Lehi Planning Commission Meeting
Agenda
August 13, 2026

VIVIAN ESTATES PHASE 5B PRELIMINARY SUBDIVISION
PLANNING COMMISSION REPORT

DRC Members Present: Glade Kirkham, Garion Rowett, Ryan Allred, Shelbey Brewer, Kim Struthers, Gary Smith, Gary Ellis, James Farnsworth, Luke Seegmiller, Brad Wilbur
Assigned Planner: Brittney Harris
Representatives of the Applicant Present: Nacia Franco and Austin White
Date of Plans Reviewed: 6/2/26
Time Start: 2:03pm
Time End: 2:32pm

OVERALL GRADING PLAN

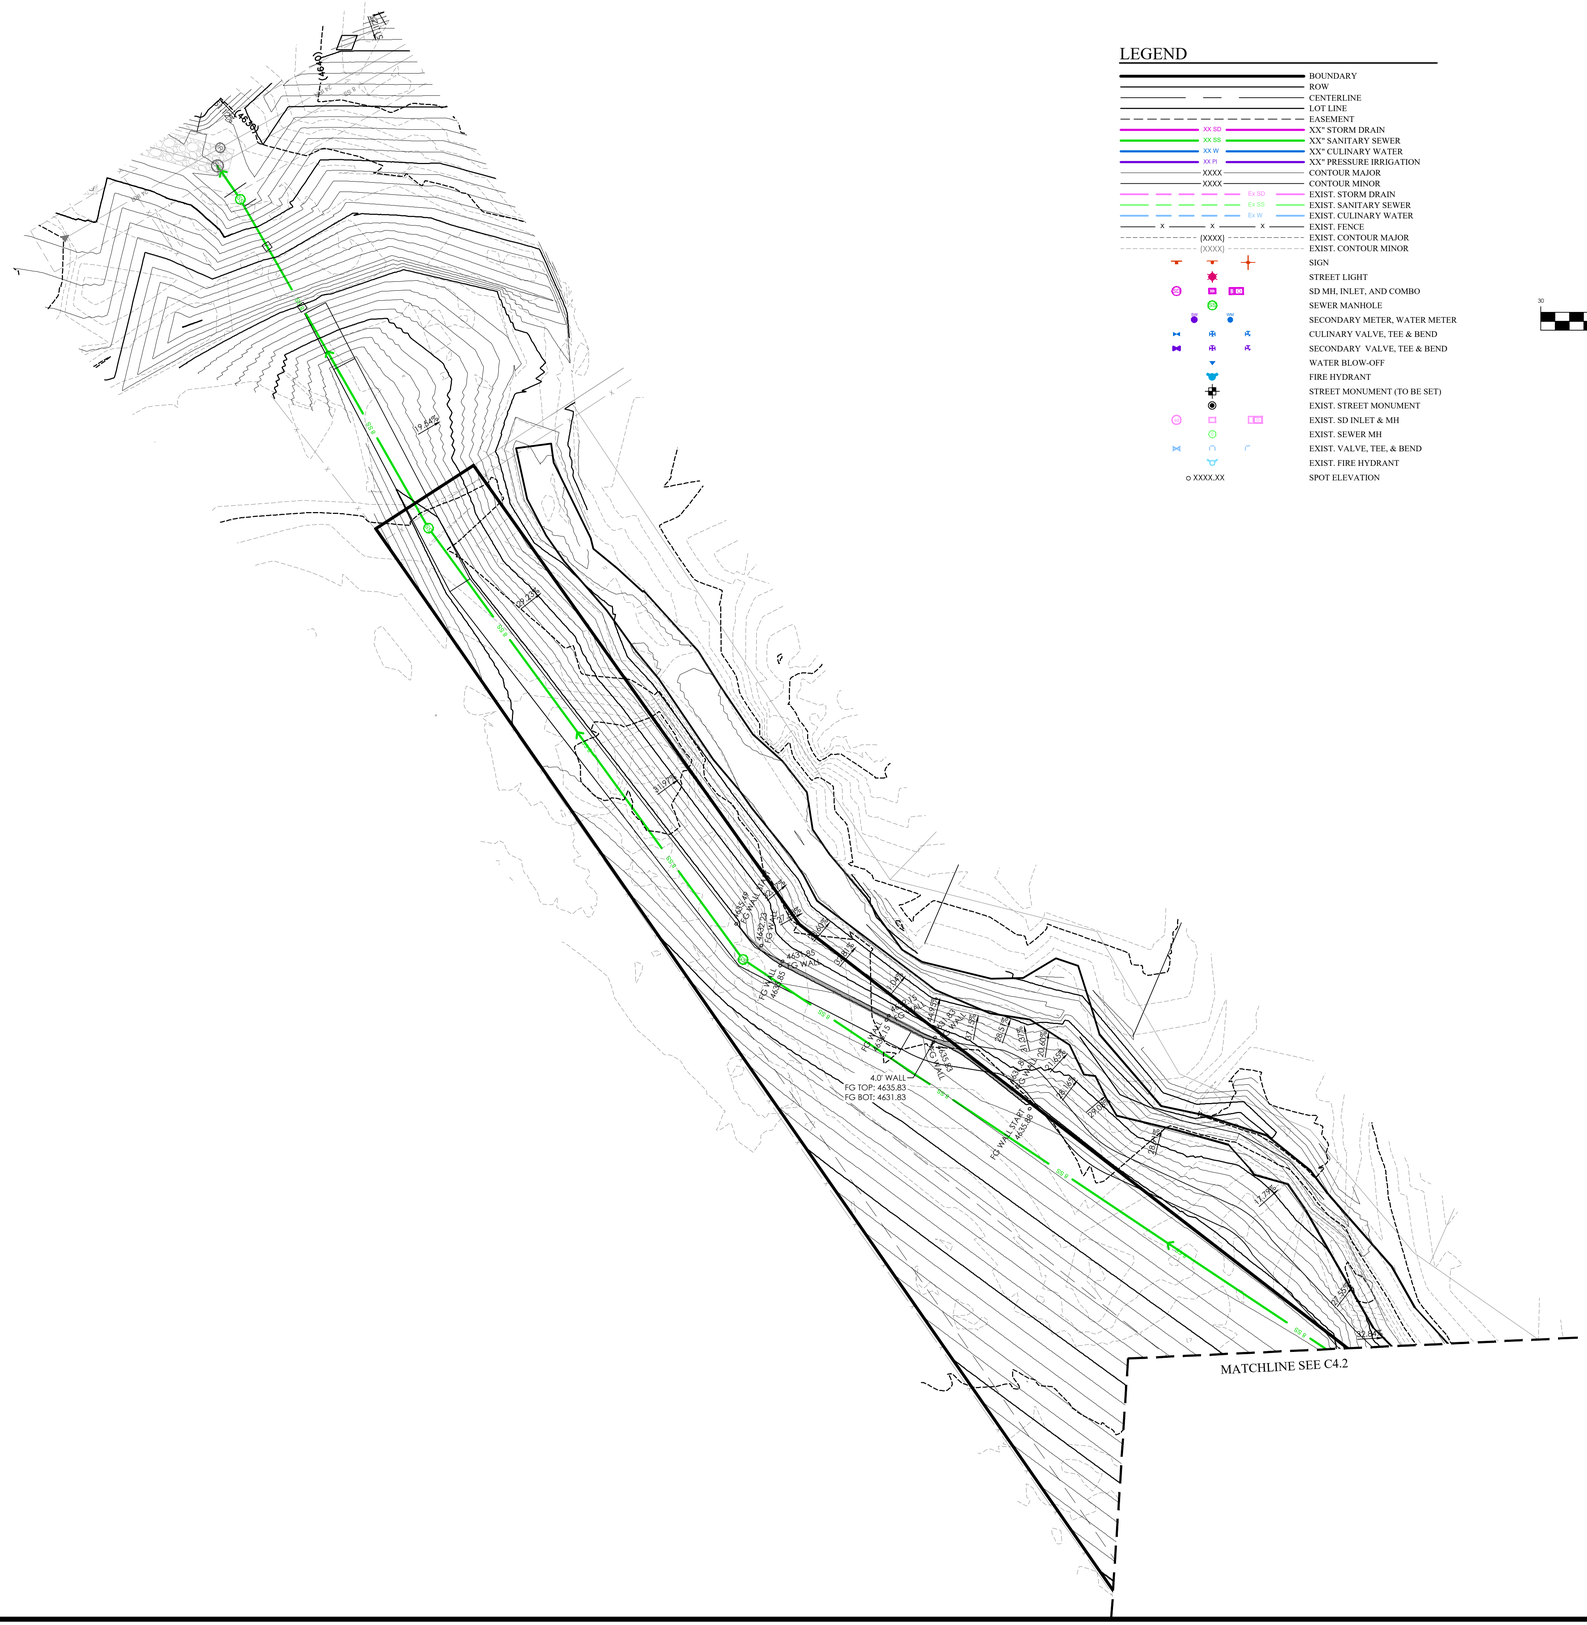
1. Add note to all grading sheets: Water and fire protection must be provided during all grading activities within this wildland urban interface.
2. Hatch all lots that butt up to the natural vegetation and provide note stating these lots will require fire sprinklers or a 100' buffer.

2. Add note to all grading sheets: Water and fire protection must be provided during all grading activities within this wildland urban interface.
3. Hatch all lots that butt up to the natural vegetation and provide note stating these lots will require fire sprinklers or a 100' buffer.
